Re: Deletion of Jensen Property
Mountain Coal Company
C.V. Spur Processing/Loadout Facility
ACT/007/022-93A; Folder #2
Carbon County, Utah

In response to your denial letter of 7/20/93, Mountain Coal Company is herein submitting 3 complete copies of a new proposed amendment to delete the Jensen Property from the C.V. Spur Permit.

Title of Change: *Deletion of Jensen Property from C.V. Spur Permit.*

JENSEN PROPERTY BERM
(TYPICAL CROSS-SECTION)

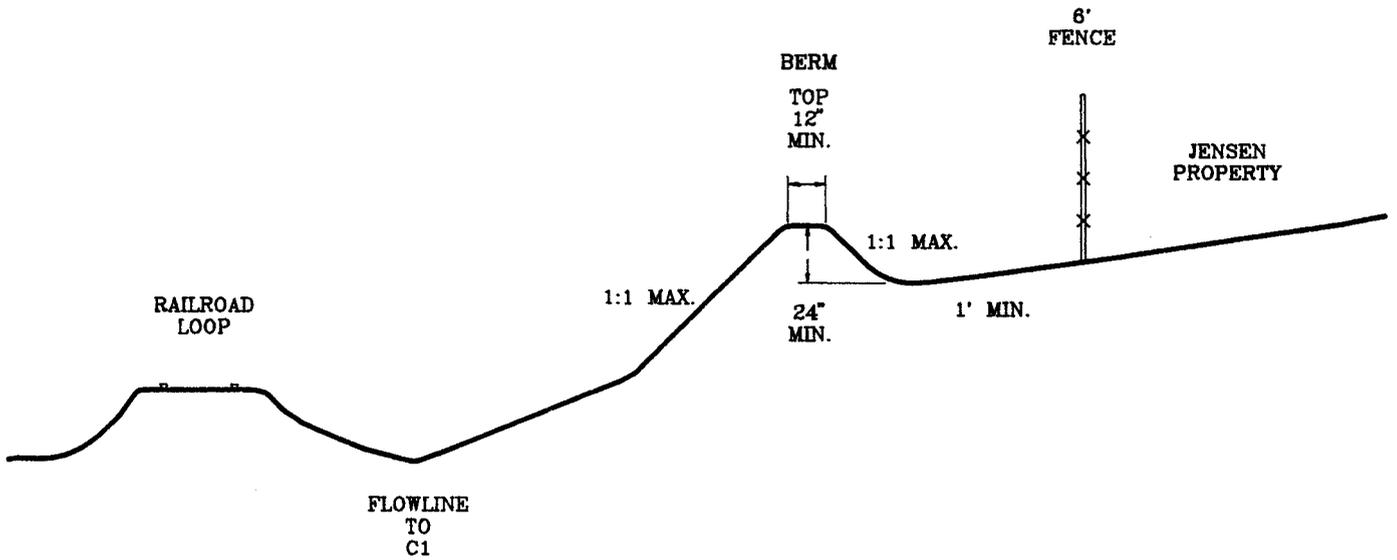
- (5) Mountain Coal Company is now requesting the deletion of this property from its permit. The drainage from the Jensen site can easily be diverted eastward along the railroad by the elimination of the above mentioned culvert and construction of a berm outside the Jensen property fence, as shown on Plate 3-2. The berm would be constructed on Mountain Coal Company property and at our expense. Designs for the berm are provided in Chapter 7 of the Permit.

The proposed berm around the Jensen property will provide for diversion of drainage from this area eastward along the railroad loop to the 24" culvert beneath the main line of the railroad at the southeast corner of the property. Cross-Section of the proposed berm is shown on Figure 7-9, and location is shown on Plate 3-2.

The berm is more than adequate to divert the entire runoff from Area 5e shown on Figure 7-5 (p.7-65) and described on table 7-17 (p.7-69), which shows an expected runoff of only 0.318 acre feet with a design peak flow of 0.81 cfs (Culvert C-1, p. 7-88a),. Culvert C-1 will remain in place to divert drainage from the disturbed area remaining between the Jensen Property and the railroad loop.
